## URBAN RENEWAL AGENCY AGENDA

<b>Meeting Date: August 1, 2022</b>		<b>Subject: URA Resolution No. 327</b> Authorizing the City Manager to Execute a Second Amendment to the Construction Contract with Moore Excavation Inc. for the 5 <sup>th</sup> Street / Kinsman Road Extension Project (Capital Improvement Project No. 1139, 2099, 4196, 4215, & 9155)  <b>Staff Member:</b> Zachary J. Weigel, P.E. City Engineer  <b>Department:</b> Community Development	
<b>Action Required</b>		<b>Advisory Board/Commission Recommendation</b>	
<input checked="" type="checkbox"/> Motion <input type="checkbox"/> Public Hearing Date: <input checked="" type="checkbox"/> Resolution <input type="checkbox"/> Information or Direction <input type="checkbox"/> Information Only <input type="checkbox"/> Board Direction <input checked="" type="checkbox"/> Consent Agenda		<input type="checkbox"/> Approval <input type="checkbox"/> Denial <input type="checkbox"/> None Forwarded <input checked="" type="checkbox"/> Not Applicable  <b>Comments:</b> N/A

**Exhibit A - Change Order #02  
Pay Item Adjustment**

## Exhibit B – Change Order #02 Pay Item Detailed Description

**1 BORING PROFILE**  
63 1" = 10'

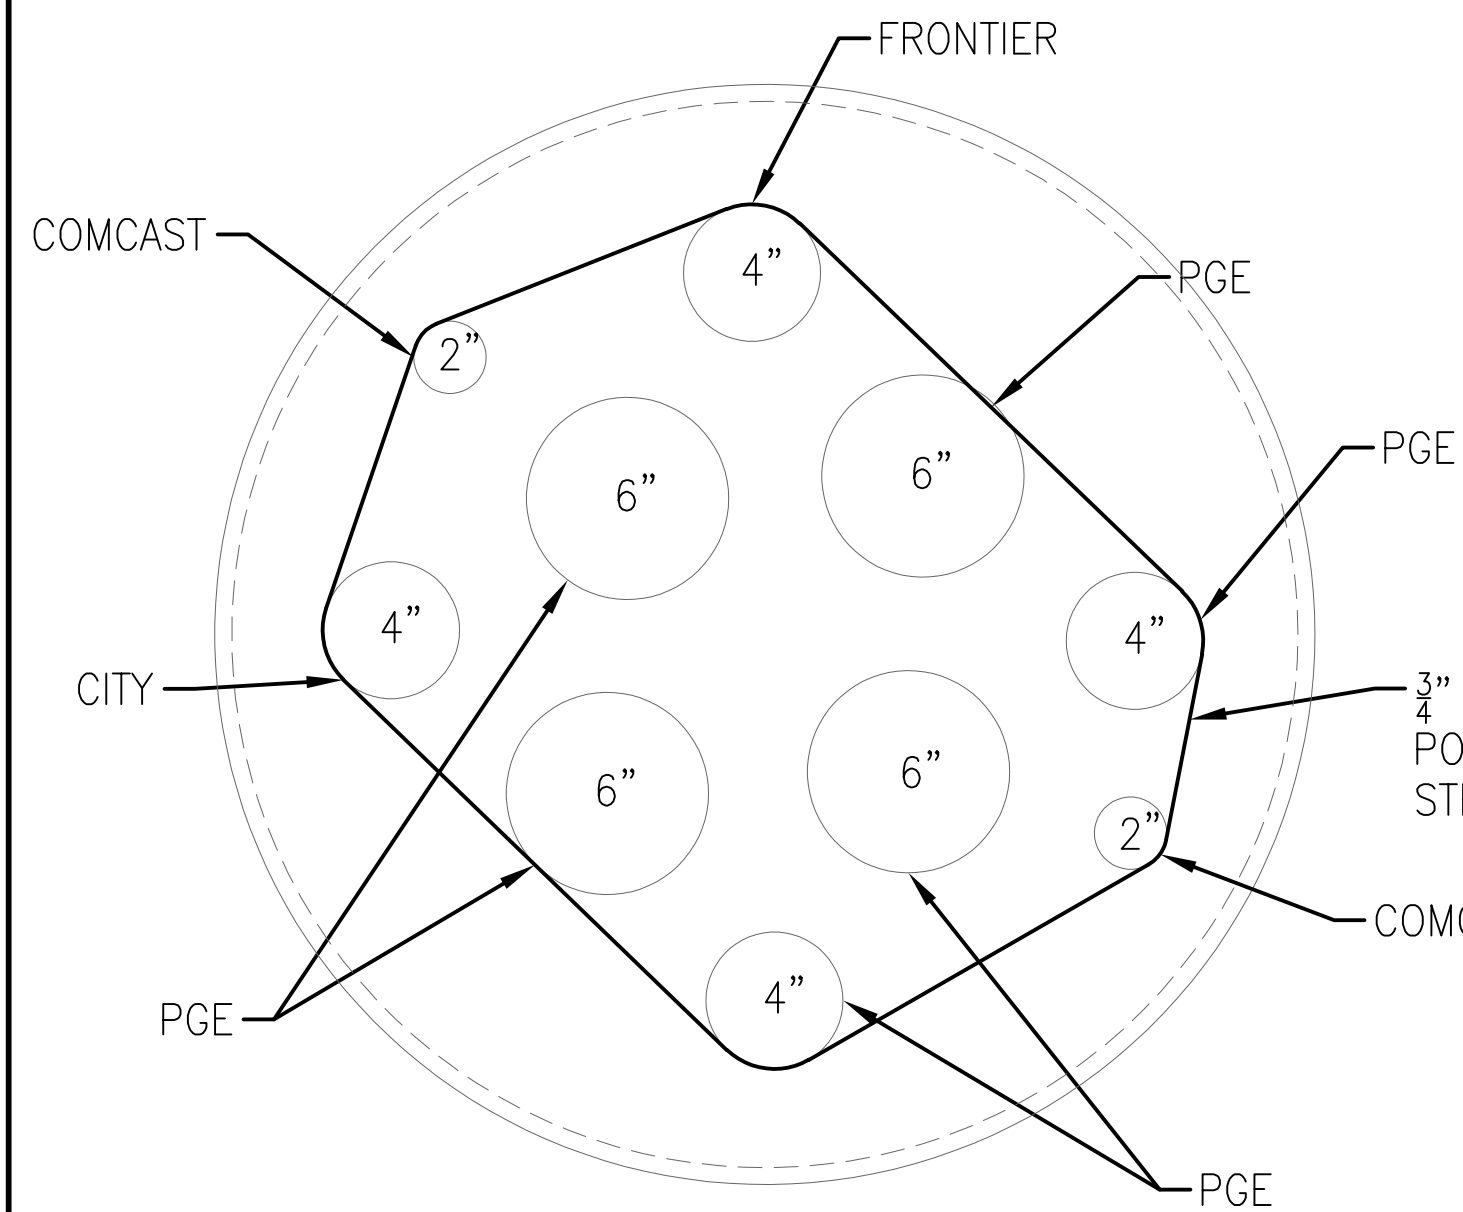
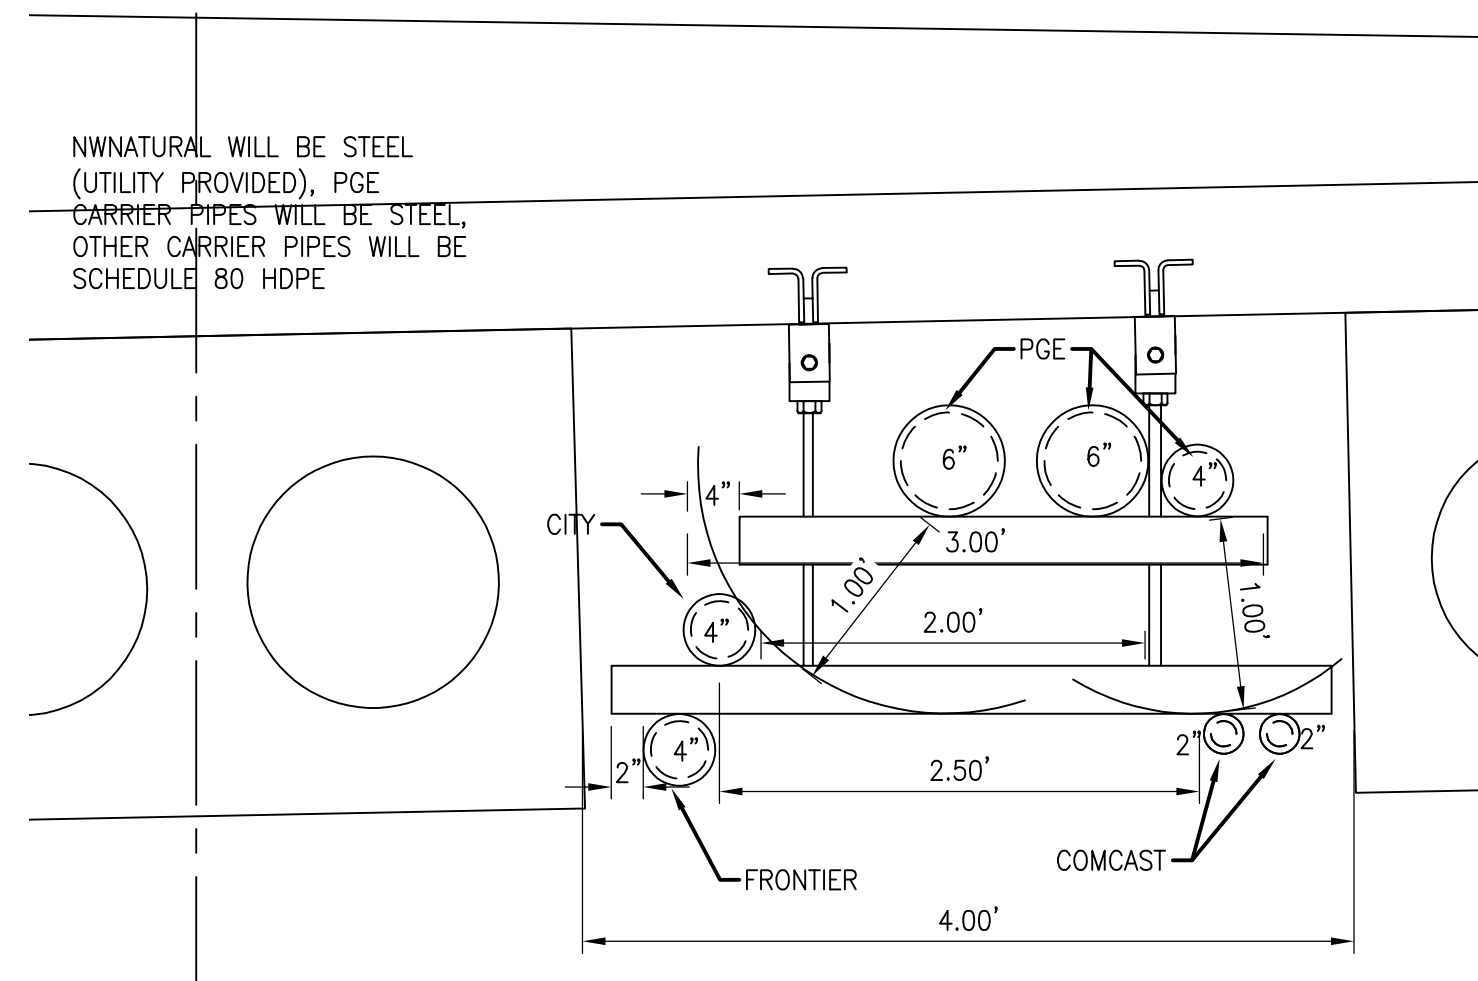
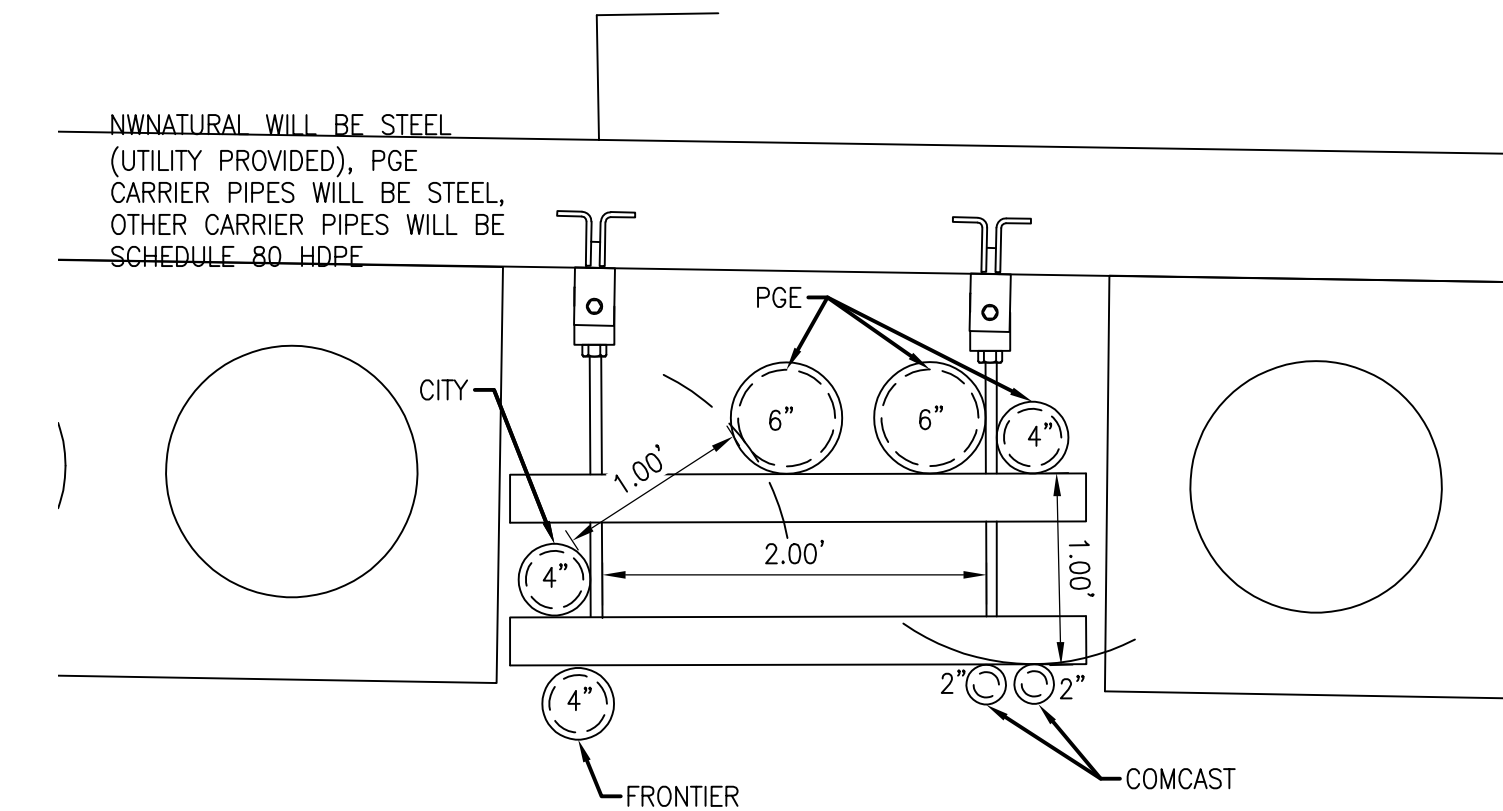
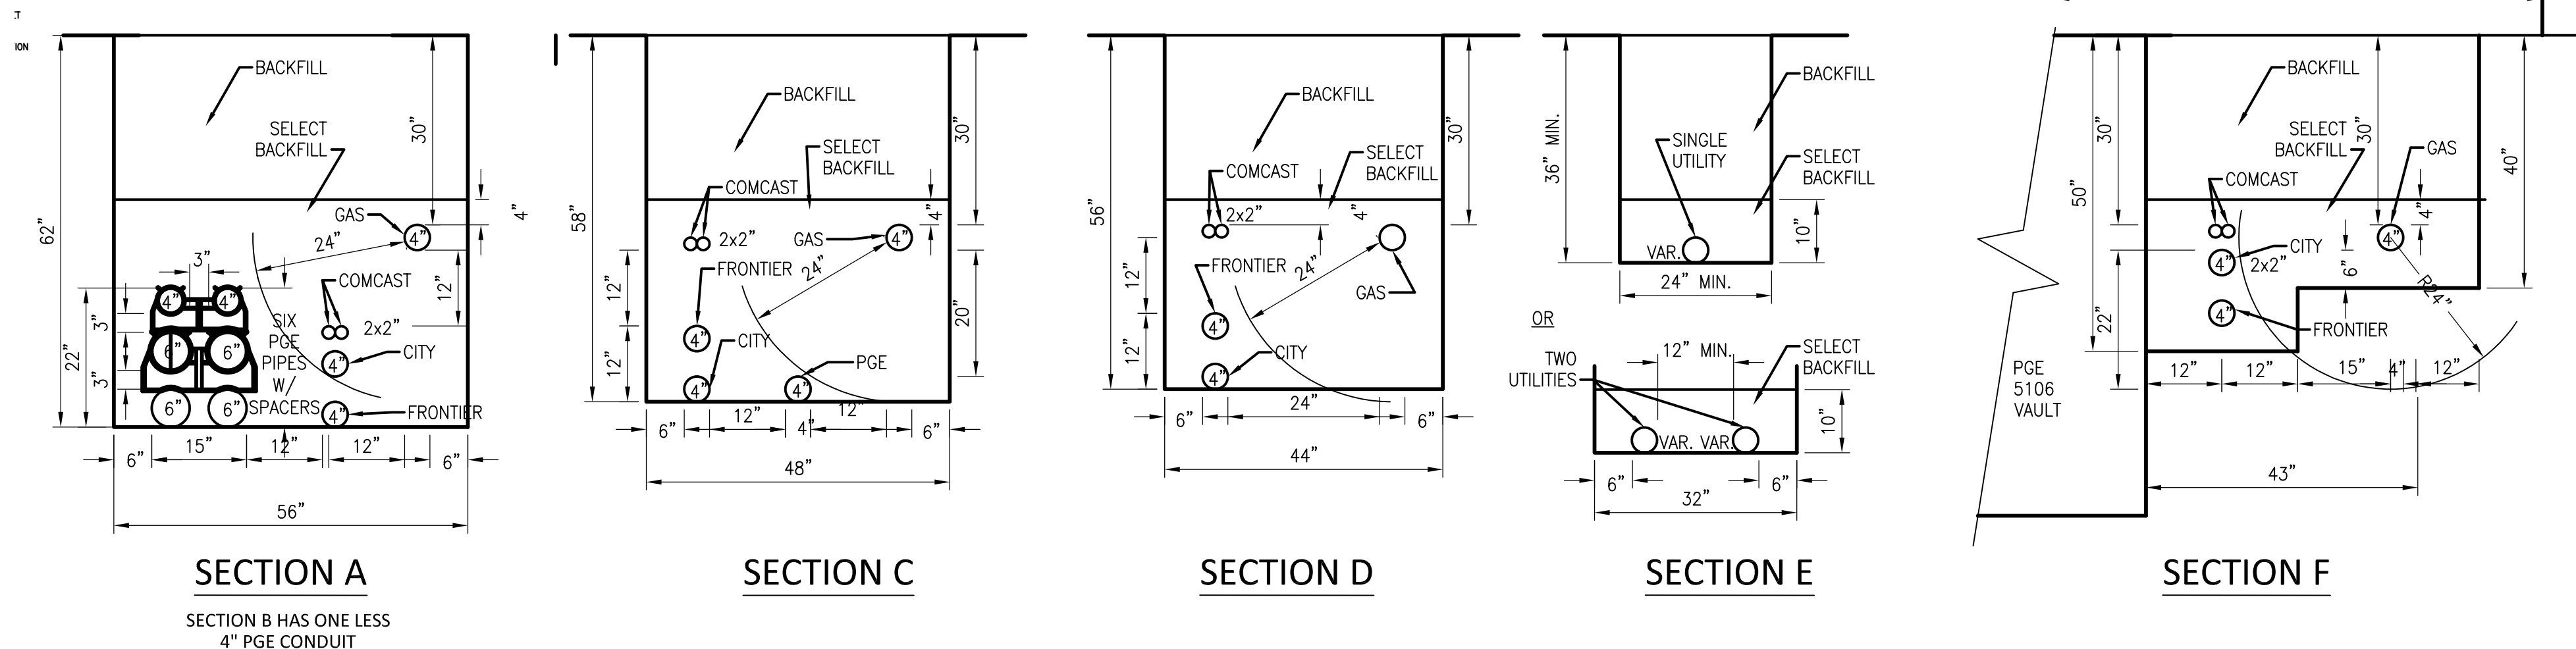
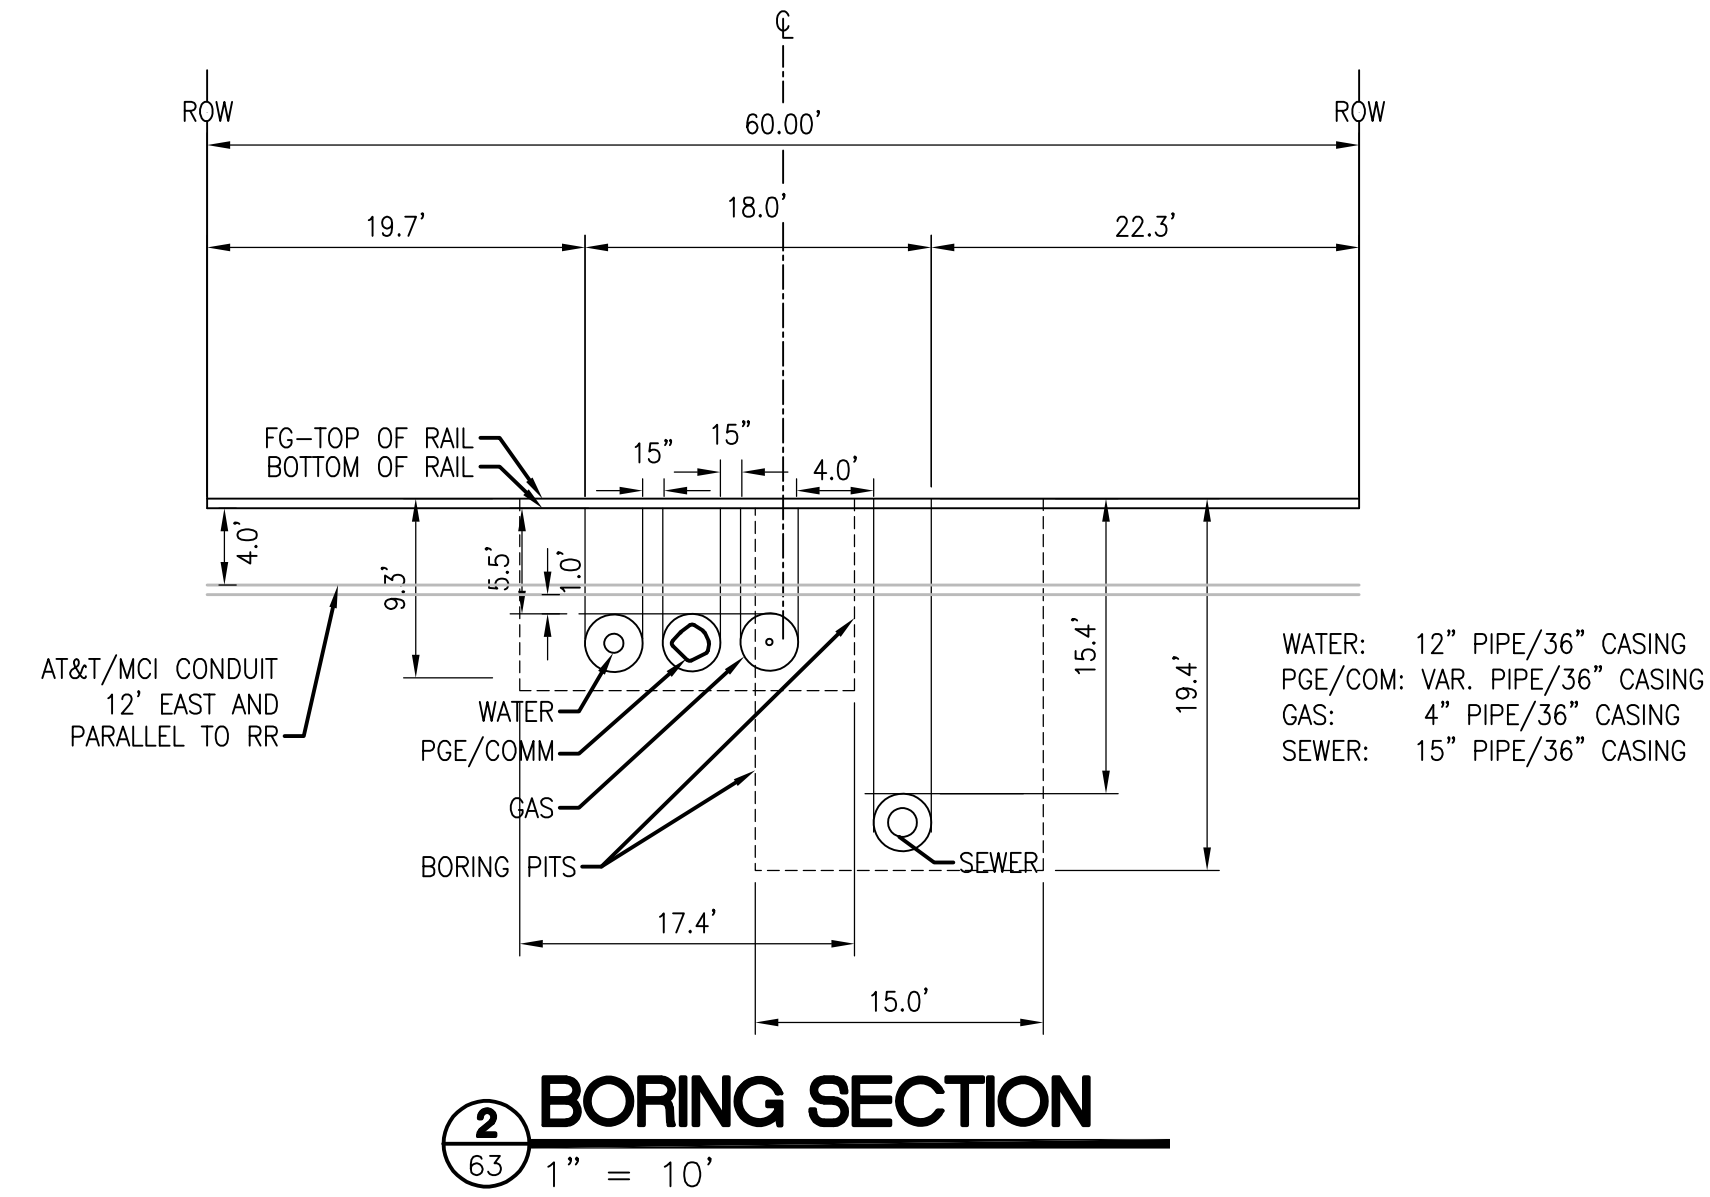
During bore installation of the 6” diameter casing pipe for the natural gas pipeline crossing beneath the railroad tracks, the Contractor was unable to complete the work after a number of attempts due to the presence of boulders. The Contractor determined that the small size of the casing pipe does not provide enough room to access and remove the conflicting portions of boulders. The Contractor proposes an upsized 36” diameter casing pipe to provide the needed space to remove conflicting boulders and complete installation of the needed casing pipe. In addition, the Contractor mistakenly installed a larger, 36” casing for the City water pipeline, rather than the 18” casing called for in the construction documents. The utility casing pipe design changes for the railroad crossing are included on pages 23-24 of Exhibit C.

Contractor agree to share approximately half of the additional incurred costs as documented by Change Order Request #005 (p. 12-22 – Exhibit C). The City’s share of costs are reflected by an increase in estimated quantity for Pay Item #57 – Installing 36 Inch Pipe Under Railroad, 7 FT Depth and a decrease in estimated quantity for Pay Item #55 – Installing 6 Inch Pipe Under Railroad , 7 FT Depth.

MEI Doc Control Reference: RFI 080

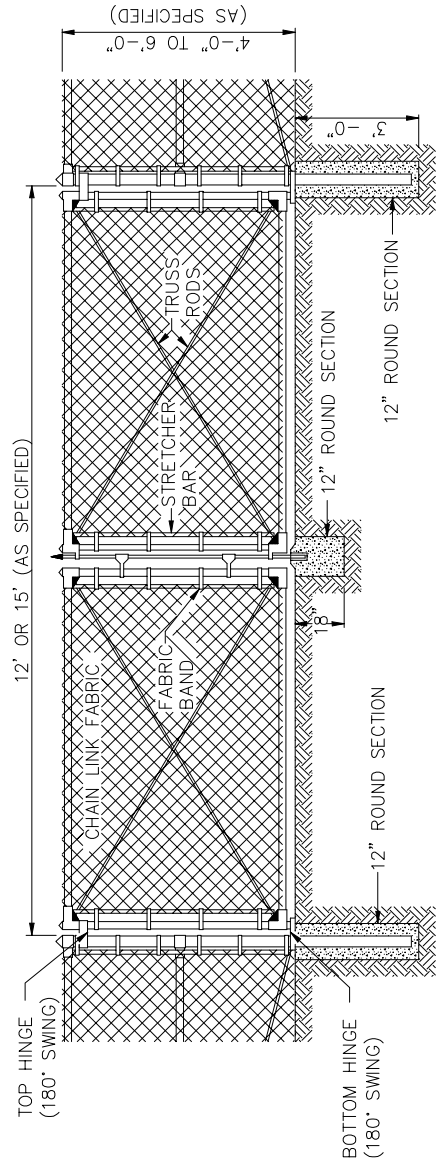
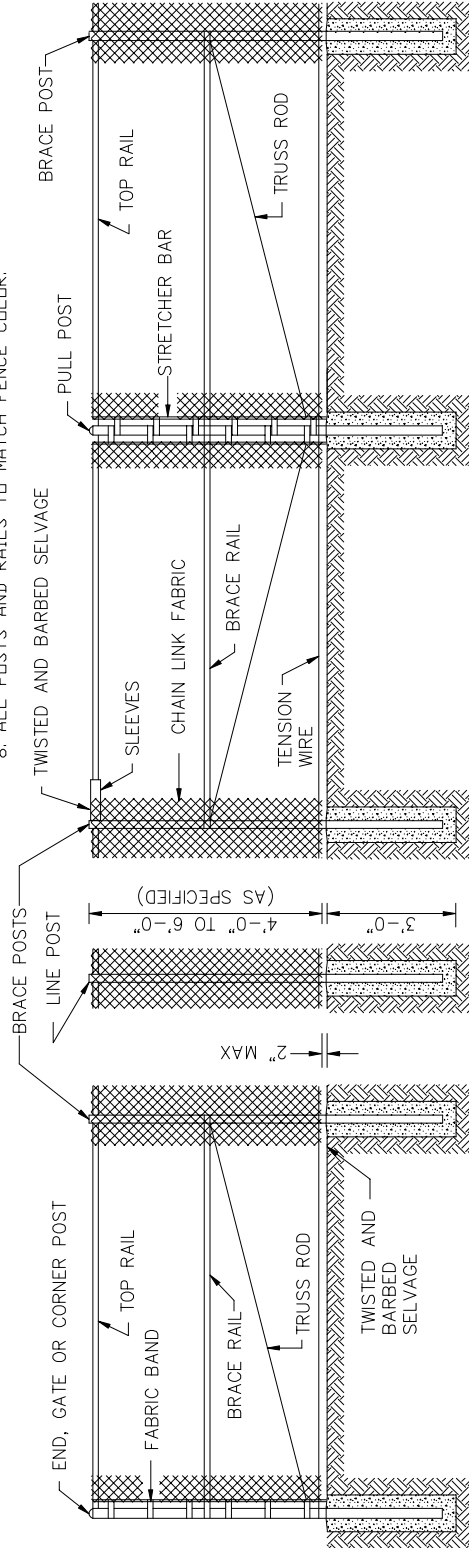
Sheet PP-03 Note 25 calls for a 31" height guard rail.

Please confirm if the height should remain 31"

There is no guard rail called for on the west side of the bridge. There is a significant fall hazard with the wing wall of the bridge directly adjacent to the sidewalk. Please confirm if guard rail is needed or not

The guardrail is for vehicle lane departure and is required per the FHWA roadway length of need calculations, not related to OSHA requirements for pedestrians.

The city would like to add chain link fence. Please provide a proposal for installing 4-foot high black chain link fence (CWS standard detail No. 792) for each bridge. The fence locations would be from the corner for the bridge railing along the back side of the wing walls at all four corners. Please follow OSHA standards and requirements. The tops of the poles should be situated as best as possible below the decorative bridge deck railing. Confirm field location and fit with city inspector prior to placing.
